Note: Staff reports can be accessed at <https://www.mncppc.org/883/Watch-Meetings>**Detailed Site Plan
Alternative Compliance
Forestville Center****DSP-16039
AC-21014**

REQUEST	STAFF RECOMMENDATION
<p>This case was continued from the Planning Board hearing date of May 8, 2025 to June 26, 2025.</p> <p>Development of an 8,674-square-foot commercial shopping center.</p>	<p>With the conditions recommended herein:</p> <ul style="list-style-type: none">• APPROVAL of Detailed Site Plan DSP-16039• APPROVAL of Alternative Compliance AC-21014• APPROVAL of Type 2 Tree Conservation Plan TCP2-004-2025• APPROVAL of a Variance to Section 25-122(b)(1)(G)

SUBJECT: Detailed Site Plan DSP-16039
Alternative Compliance AC-21014
Type 2 Tree Conservation Plan TCP2-004-2025
Variance to Section 25-122(b)(1)(G)
Forestville Center

Figure 1: Detailed Site Plan

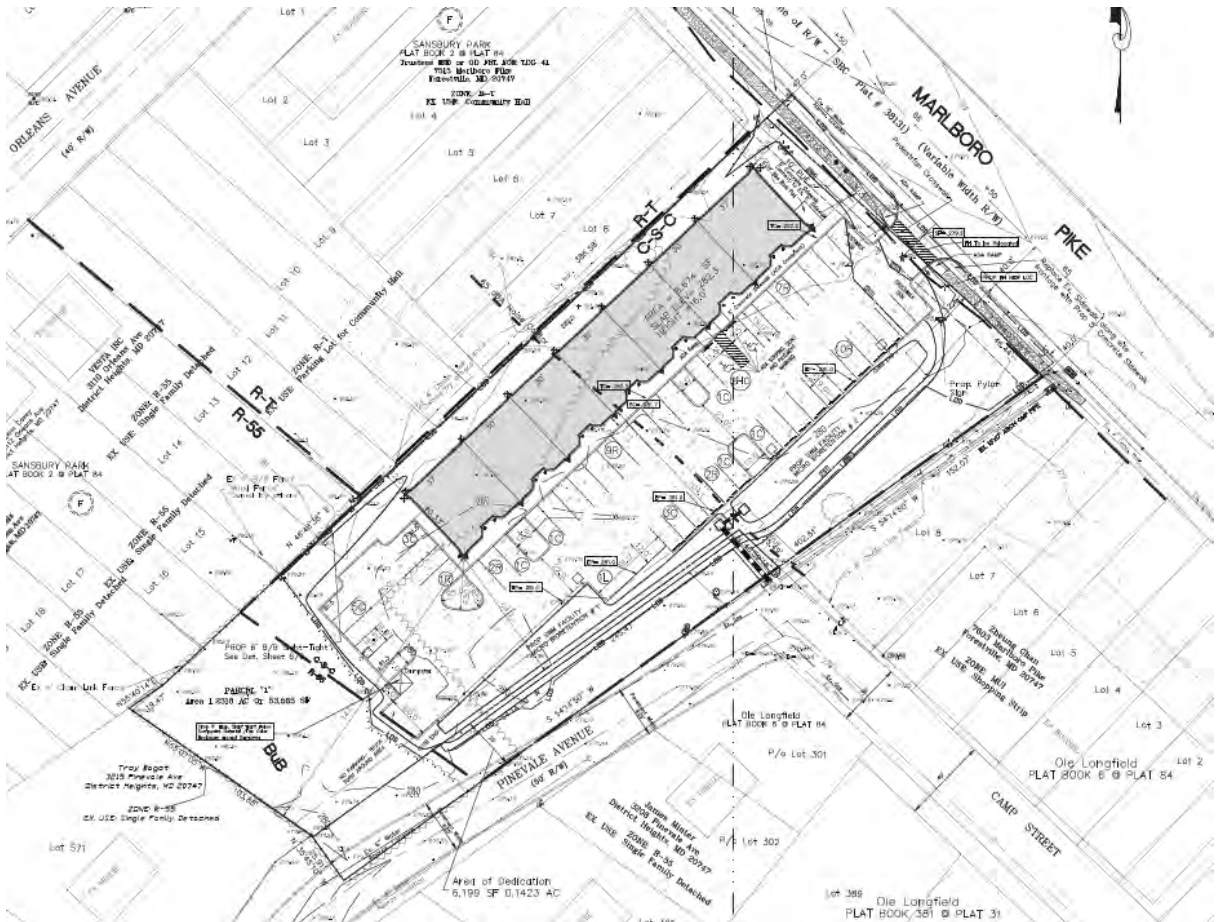
Note: *Final Plat 5-23102 for the subject property was approved by the Prince George’s County Planning Board, on November 9, 2023. As part of this approval, 0.1423 acre of land was dedicated for public use. Accordingly, this dedicated area should be excluded from the total area considered in the application. A condition is included herein requesting the applicant to remove the 0.1423 acre of dedicated land from the application and adjust notes and charts accordingly.

landscaping will screen the loading space from Pinevale Avenue. The loading area is called out on the site plan, but not clearly marked. A condition is included herein to request the applicant to add strips to clearly mark the loading area. Due to the relatively small size of the parking area, physical separation between the loading area and adjacent parking spaces is not feasible. Staff find the requirements for loading area are met.

PYLON SIGN (ENTRANCE SIGN)

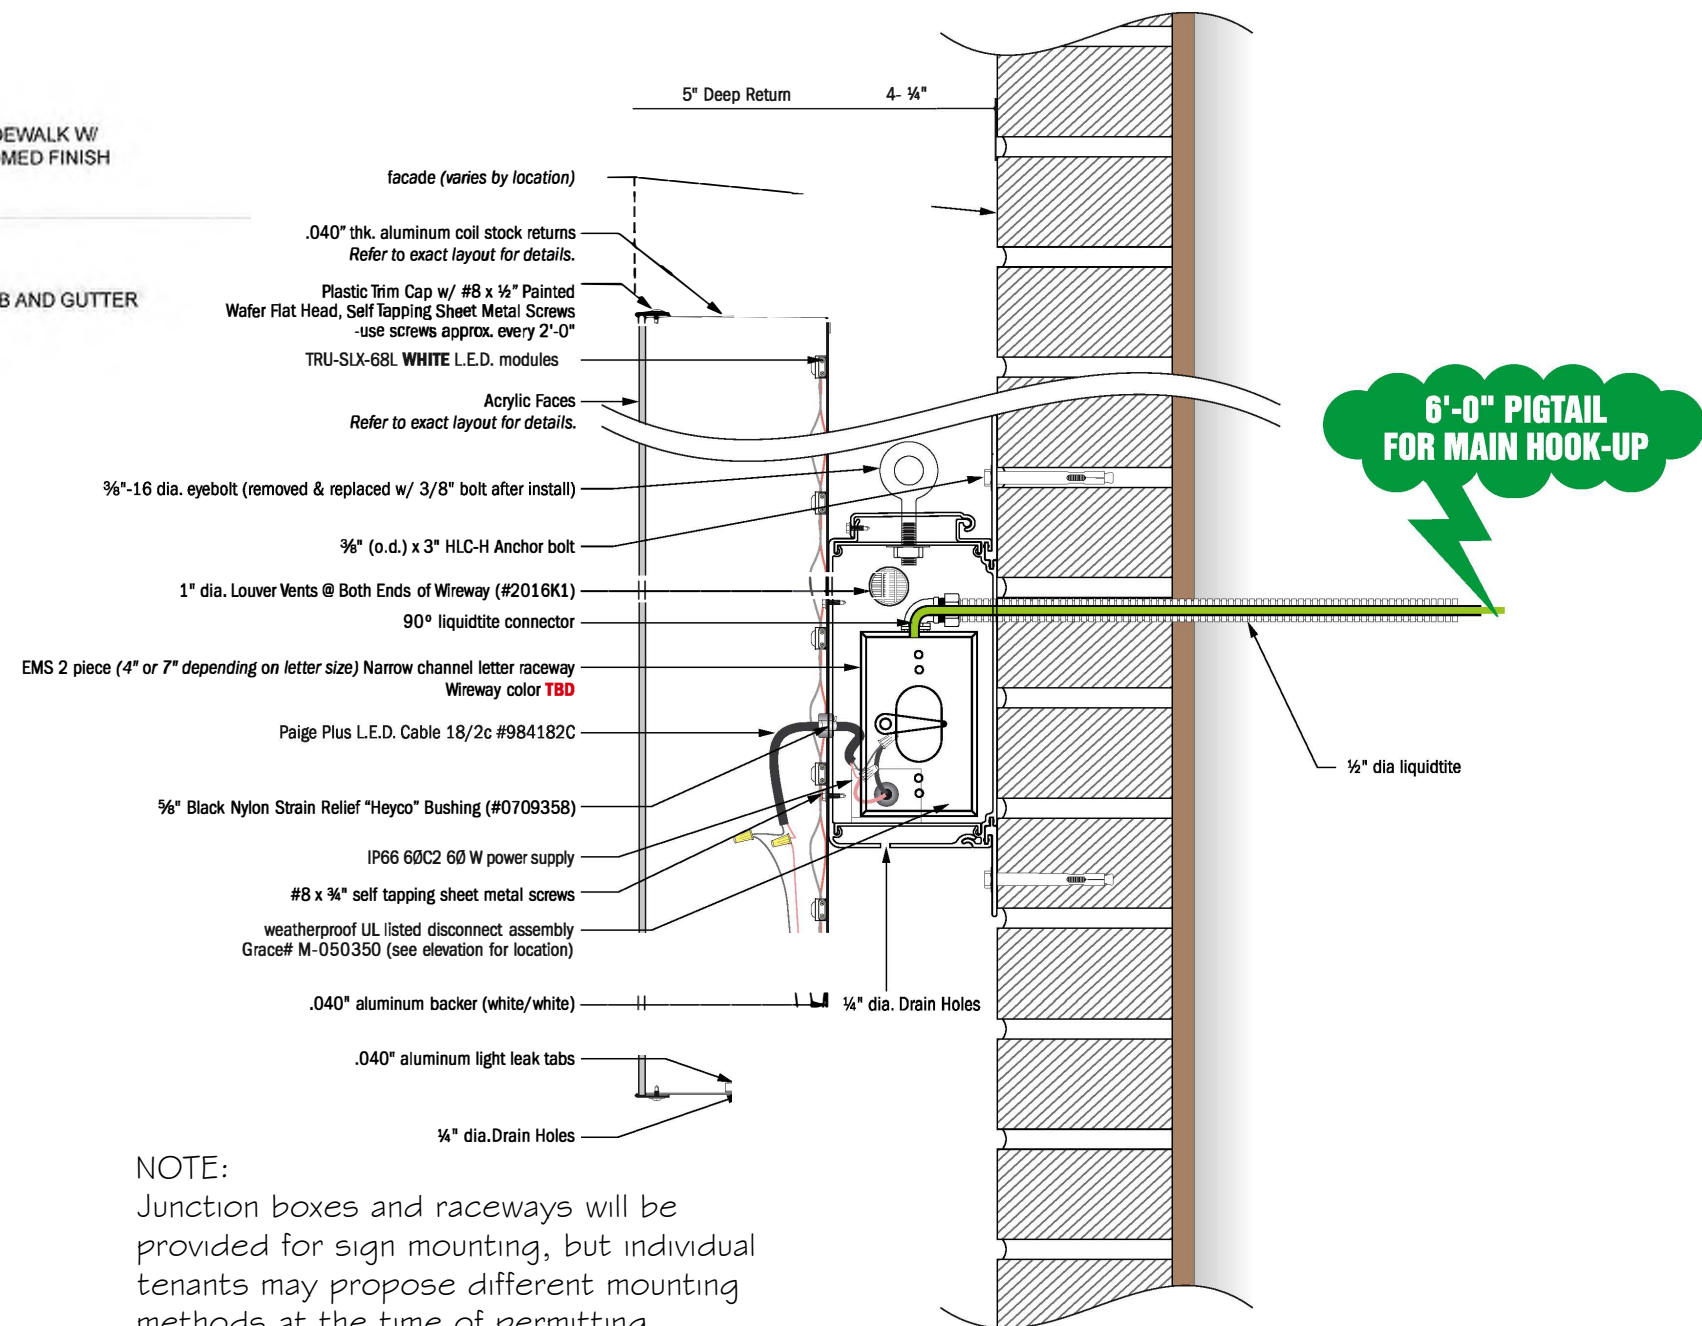
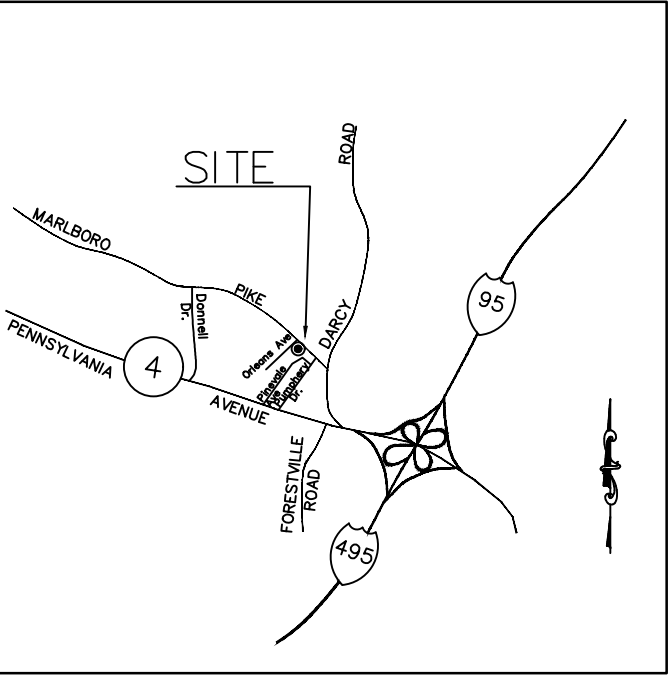
A single freestanding monument sign has an area of 30 square feet and is located at the site entrance, south of the proposed parking lot, approximately 12.6 feet from the Marlboro Pike right-of-way. Freestanding sign details are included on Sheet 6 of the DSP.

TREE CONSERVATION PLAN PLAN TYPE 2

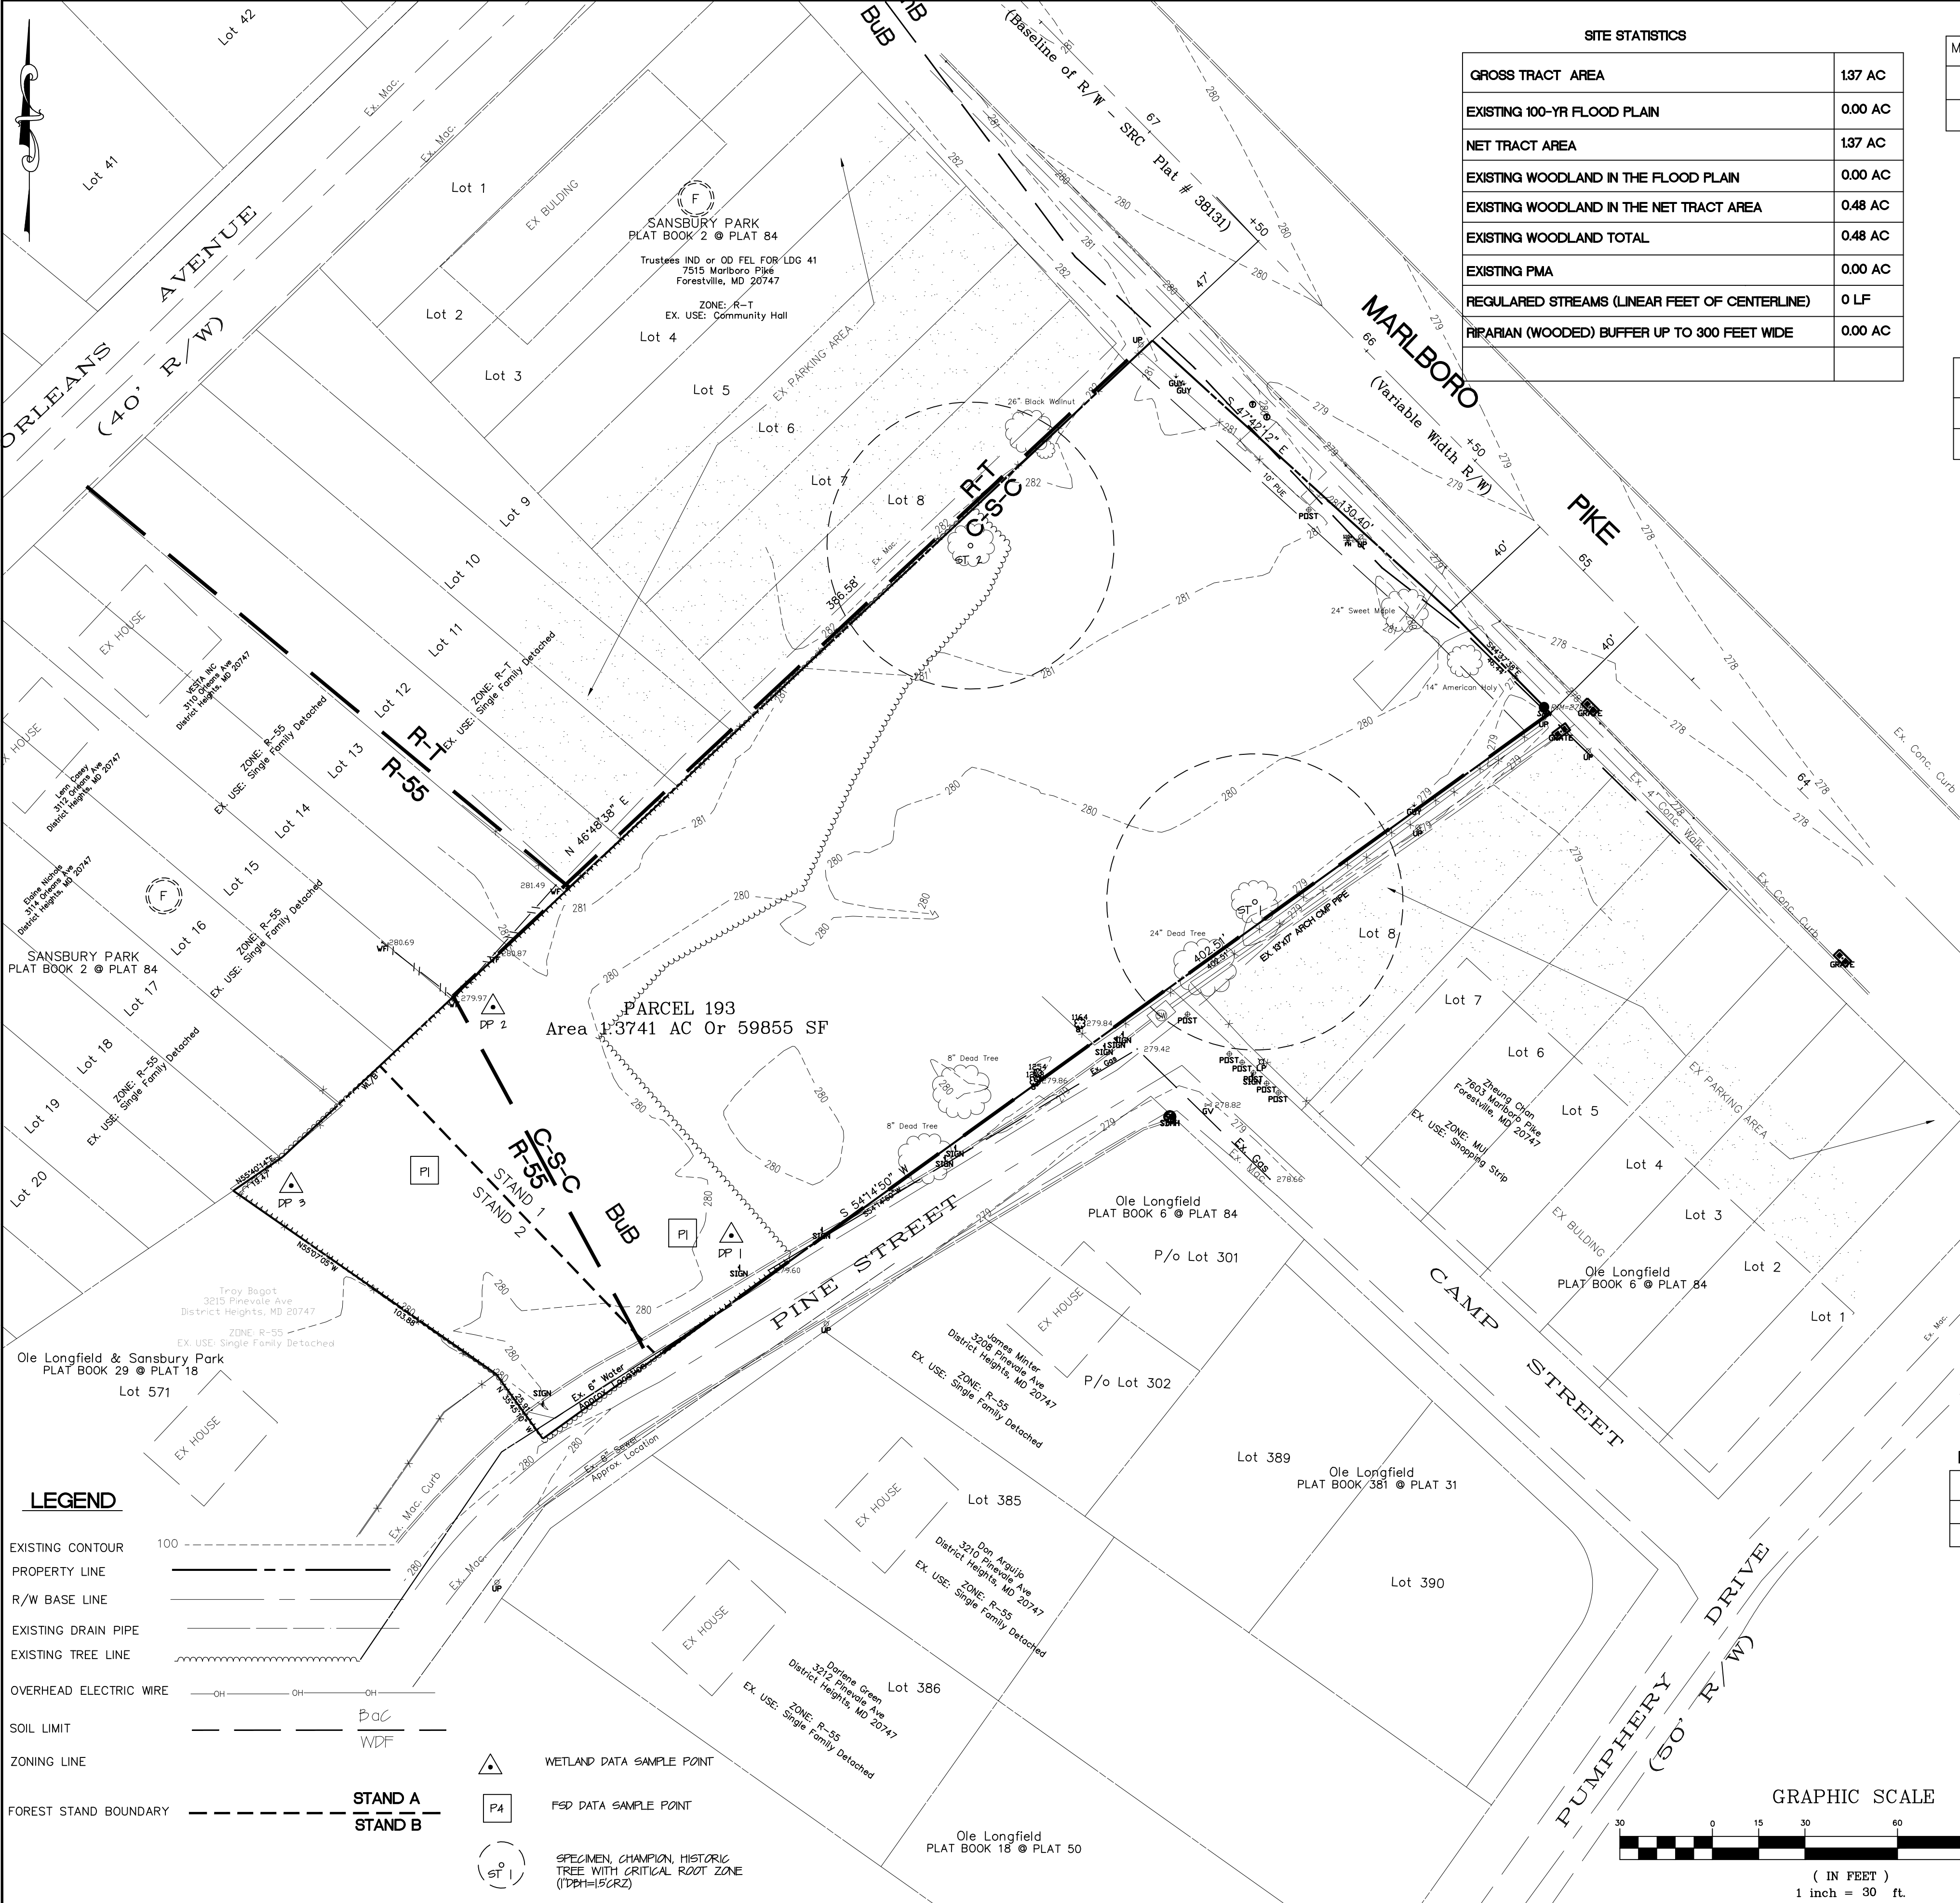
- (2) Revise the woodland and wildlife habitat conservation easement note on Sheet 1 to read as follows: "Woodlands preserved, planted or regenerated in fulfillment of woodland conservation requirements on-site have been placed in a woodland and wildlife habitat conservation easement recorded in the Prince George's County Land Records at Liber ____ folio _____. Revisions to this TCP2 may require a revision to the recorded easement."
